INTERNATIONAL CODE COUNCIL
2012-2014 CODE DEVELOPMENT CYCLE
Group B (2013)

**2013 PUBLIC COMMENT AGENDA FOR THE
PROPOSED CHANGES TO THE
2012 EDITIONS OF THE**

October 2nd – 10th, 2013

This publication contains the Public Comment Agenda for consideration at the Public Comment Hearings of the International Code Council on October 2 – 10, 2013 at the Atlantic City Convention Center in Atlantic City, NJ (see page 1). See page xxix for hearing schedule.

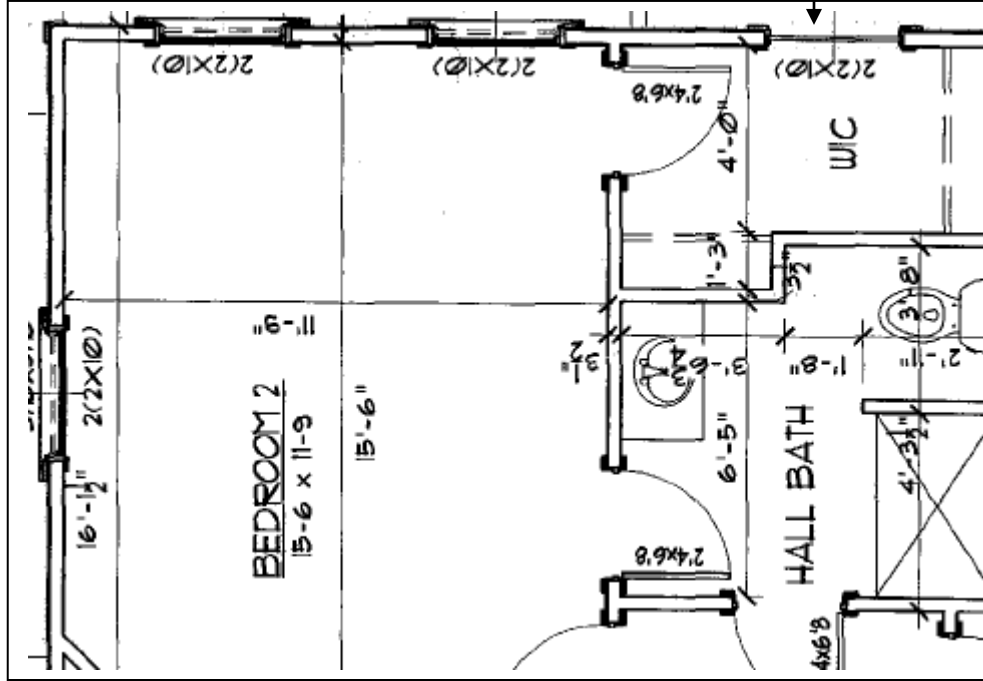
Currently this window is NOT exempt by rule # 3 (or #4) and would have to be safety glazed. If this proposal is accepted, this window would NOT have to be safety glazed.

This window is currently exempt because the arc is more the 24" from the door hinge.

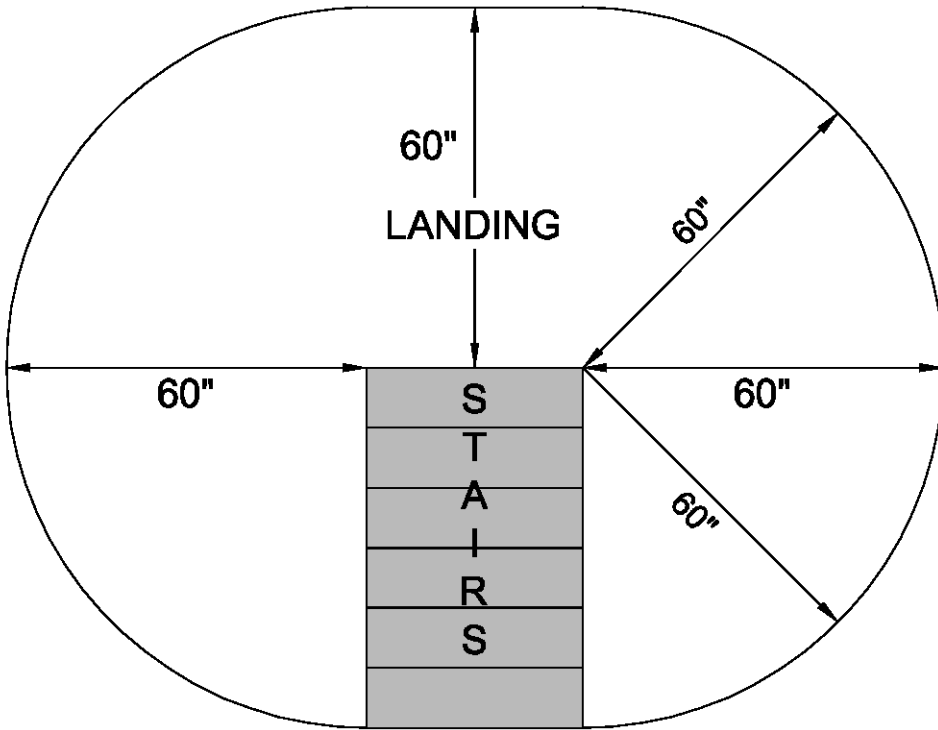
The new code language will incorporate the areas shown in the following diagram:

The current code language incorporates the area shown below in the diagram:

FIGURE 403.1(1) DISCONTINUOUS FOOTERS

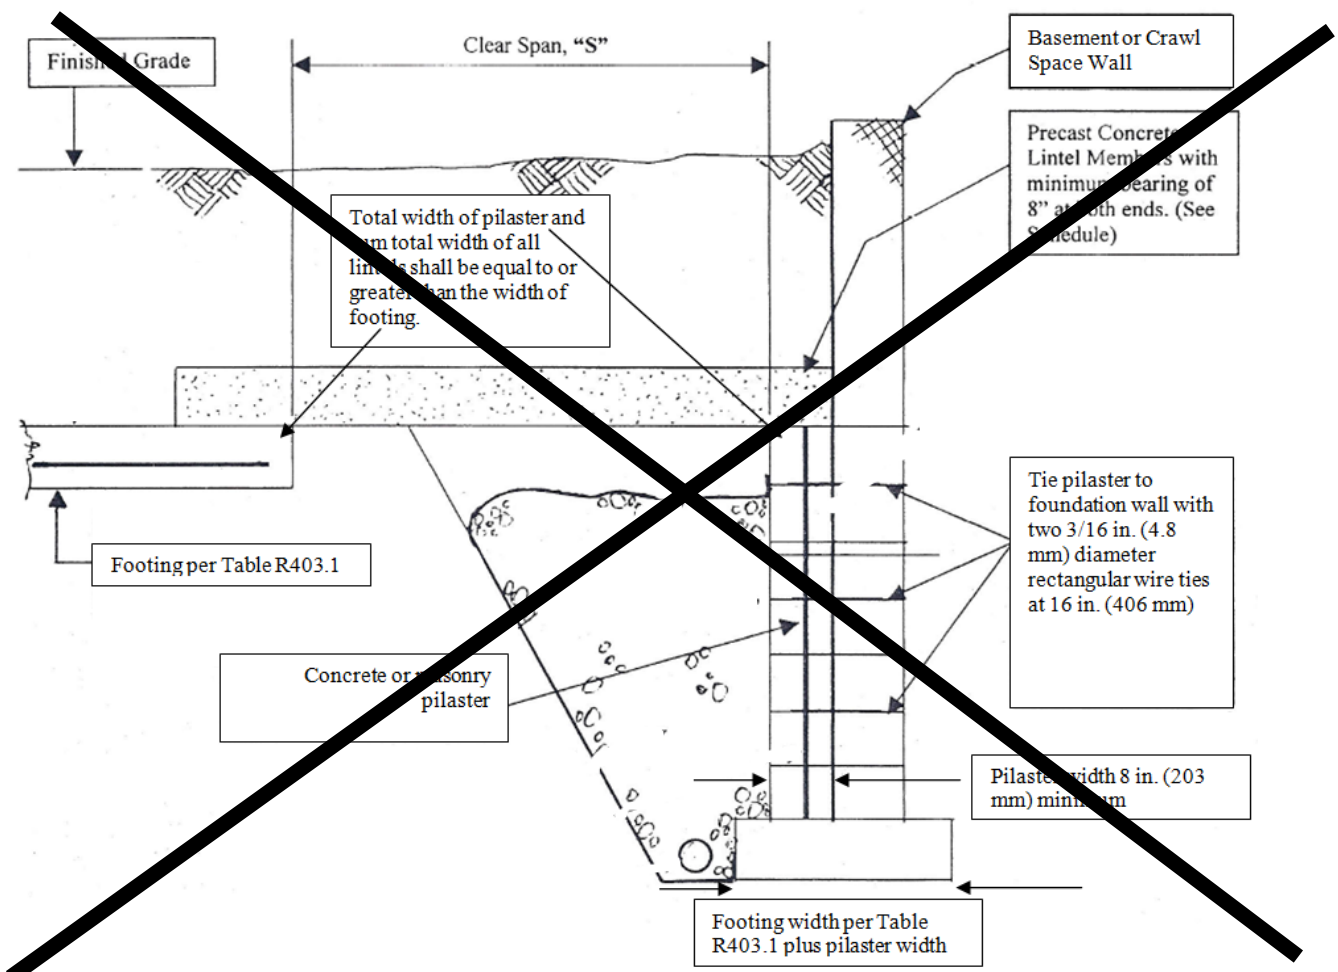
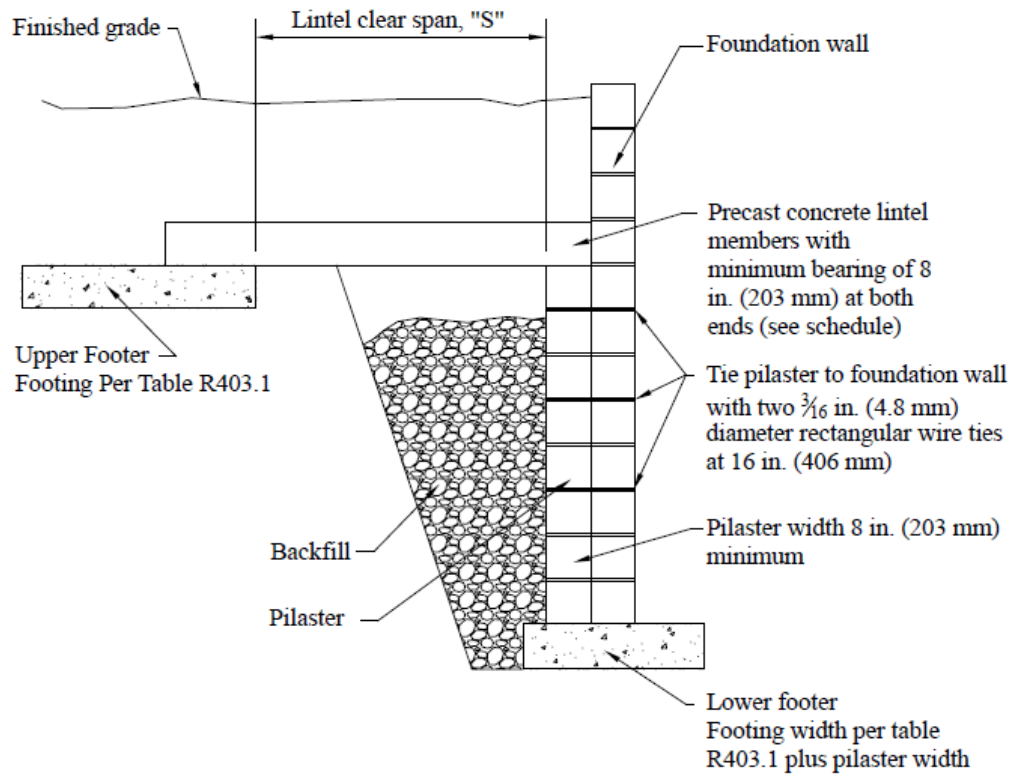
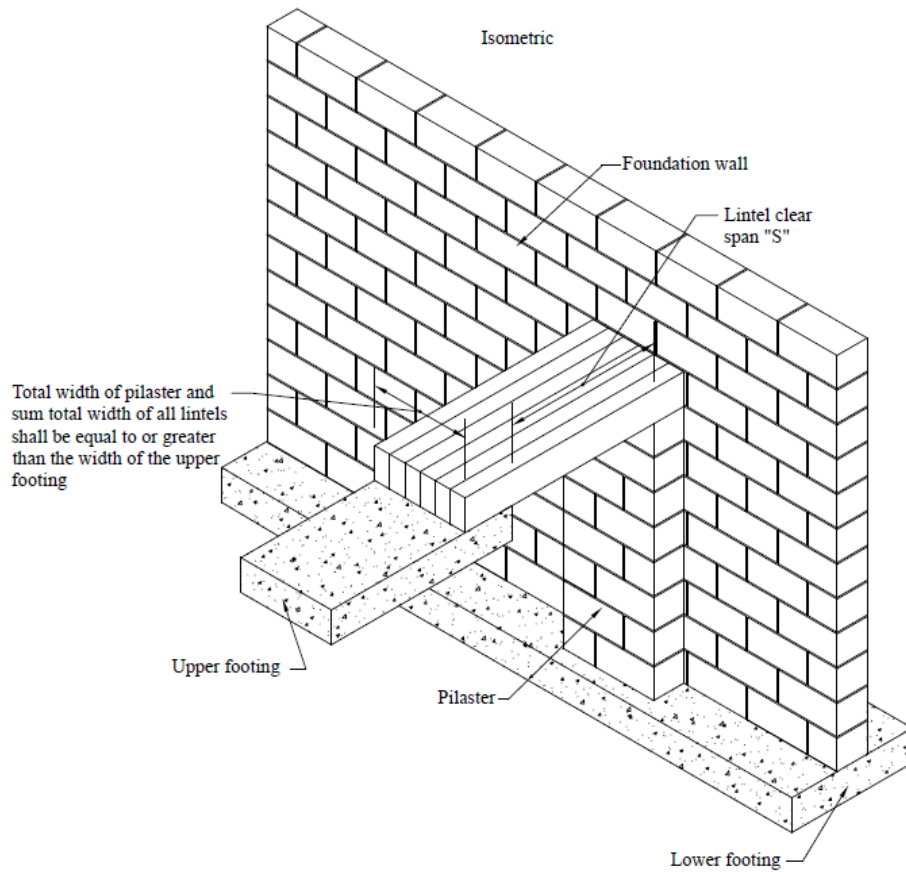
Modify the proposal as follows (delete proposed Figure 403.1(1) and replacing with new Figure 403.1(1))

Figure 4. Load-Displacement Curves for Deck With and Without Hold-downs

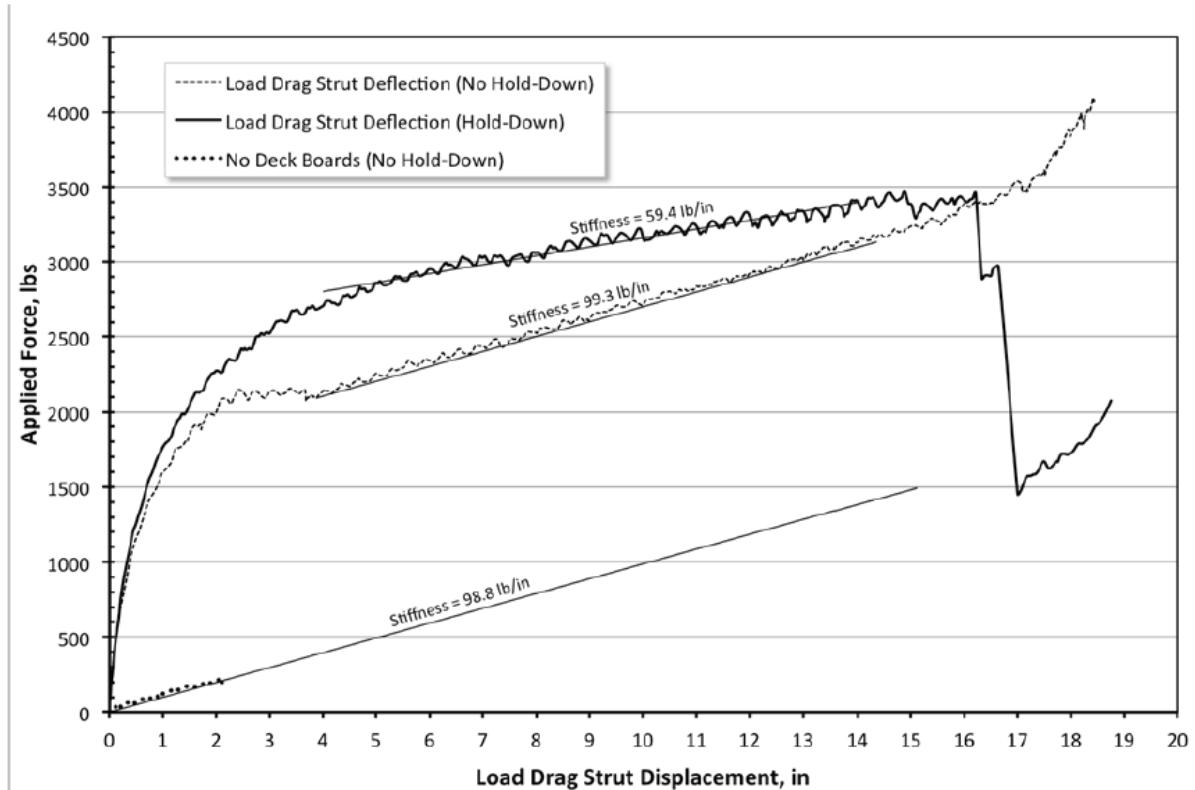
According to the graph below from the research, the deck experienced a horizontal deflection at approximately 17 inches at a load just shy of 3500 lbs. However, when loading continued upwards of 7,000 lbs, "the lag screws did not show any visible signs of withdrawal". I think the answer is that lag screws do withstand lateral loads, and band joists don't get pulled from homes.

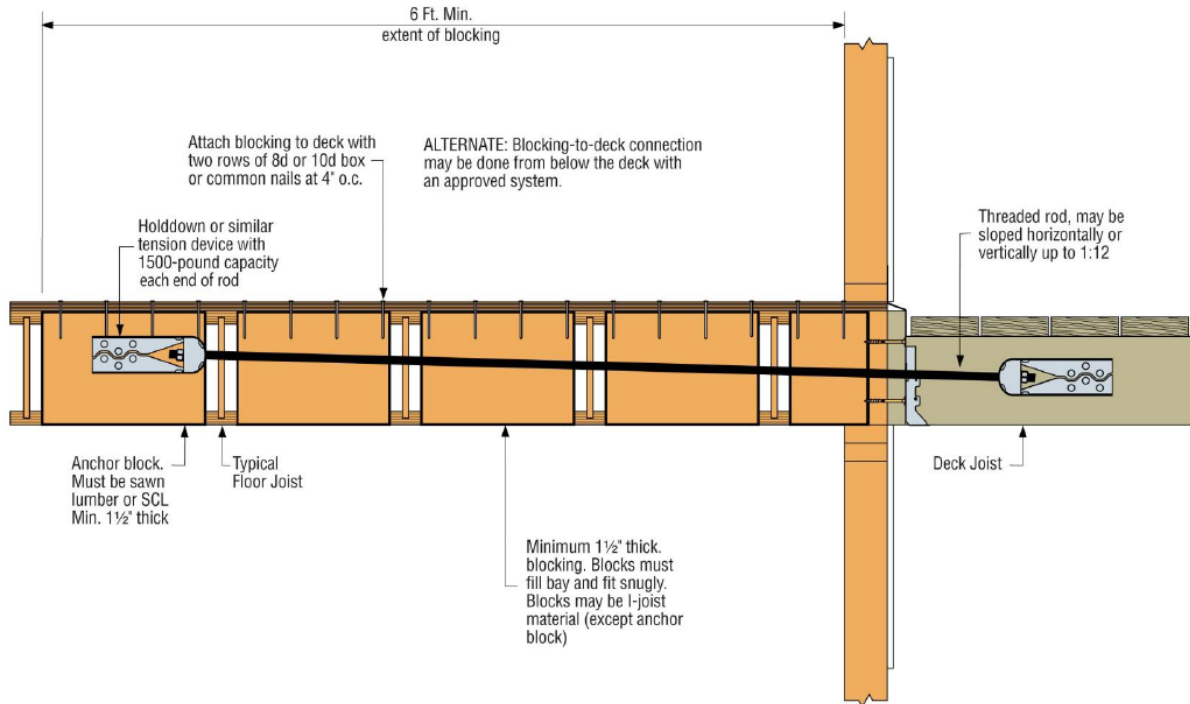
- Removal of floor finish
- Removal of ceiling finish
- Threaded rod extending at least 6 feet into the floor system with blocking in every bay.
- Floor sheathing that must be fastened to the blocking at 4 inches on center.

This is to satisfy an IRC load that is not proven and not even required.
